Service Letter No. 481

SUBJECT: Muffler and Tailpipe Support

MODELS AFFECTED: PA-24 "250" Comanches only, Serial Nos. 24-103 to 24-2174 incl.

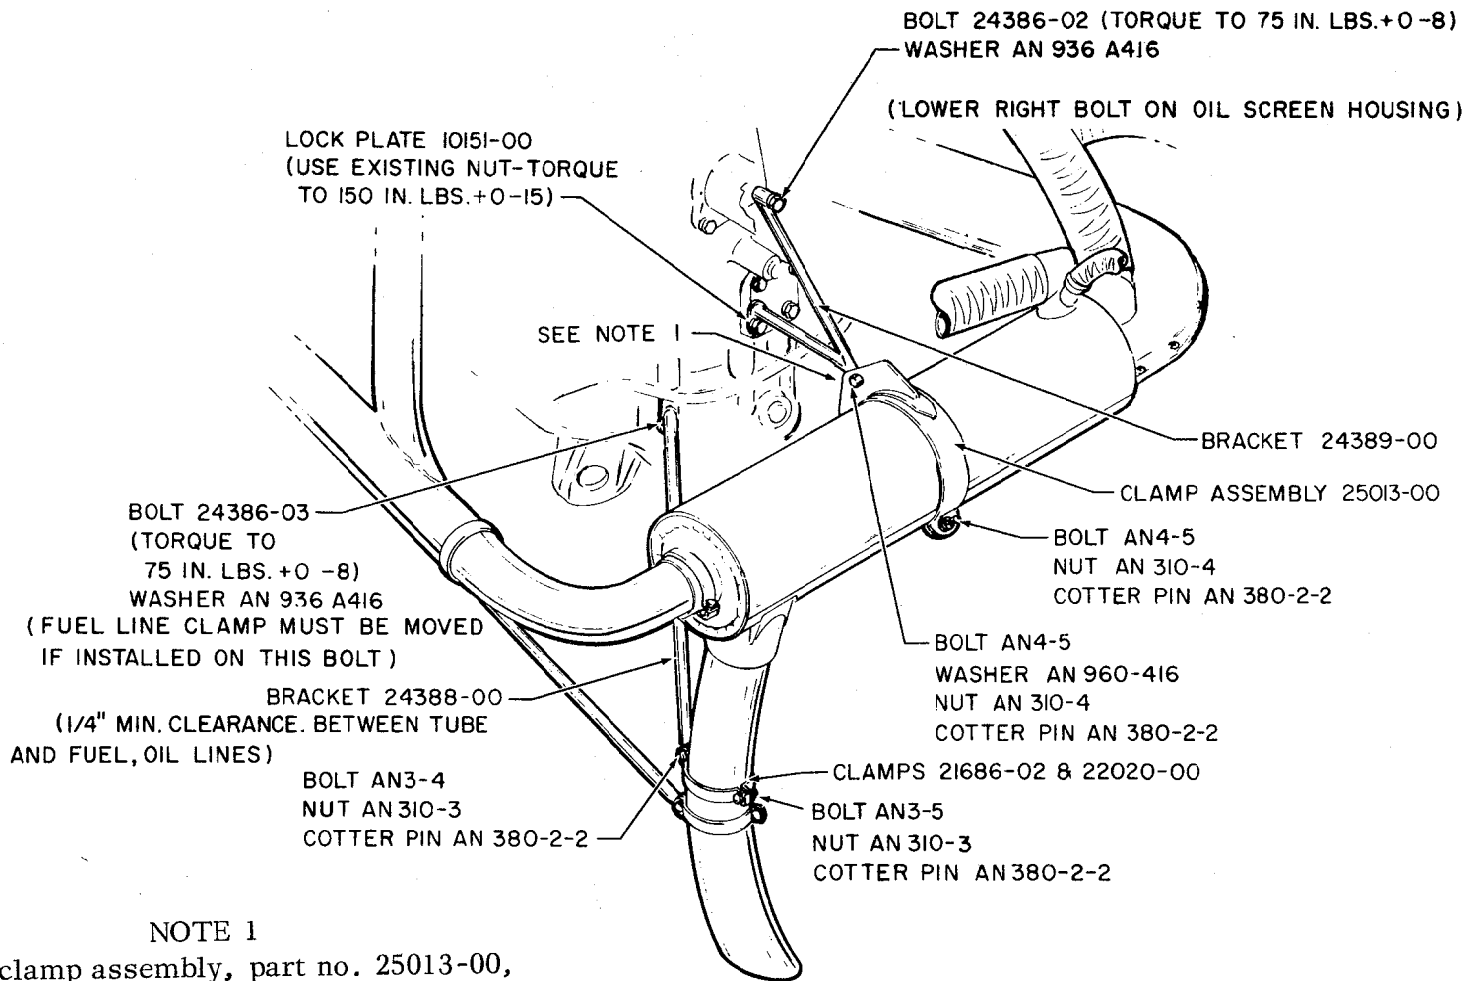
This Service Letter is to advise that a muffler support bracket and a bracket to support the tailpipe are available for installation on the subject aircraft.

These supports are applicable to the PA-24 "250" Comanches only, within the serial numbers listed above and it is recommended that they be installed on these aircraft as the additional support will be instrumental in extending the service life of the exhaust system. See sketch on the reverse side of this letter.

Drill clamp assembly, part no. 25013-00, as necessary to align with support bracket, part no. 24309-00. (Drill $.250 \pm .003$ Hole)
